S-Gold TP Cable to S-Gold/E-Gold TP Cable modification.

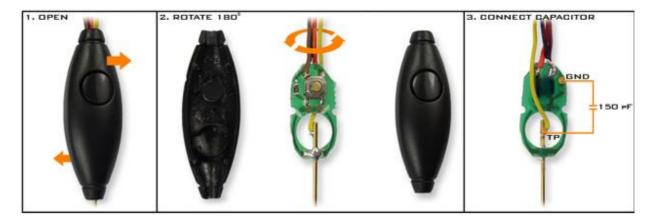
To improve stability of Dreambox "E-Gold test point" operation, customer needs to add a 150pF capacitor to S-Gold test point cable that is supplied with DreamBox. This fix is required only for some boxes due to component value displacement, but is recommended for all customers. All future boxes will be shipped with this capacitor added to the cable.

- 3. Solder this capacitor as shown on the picture (TP---|150pF|---GND)
- 4. Assemble "button probe" housing (watch for button placement)
- 5. Ensure that probe button is operational

Step by step modification:

- 1. Find small package capacitor for 150pF
- 2. Open "button probe" housing
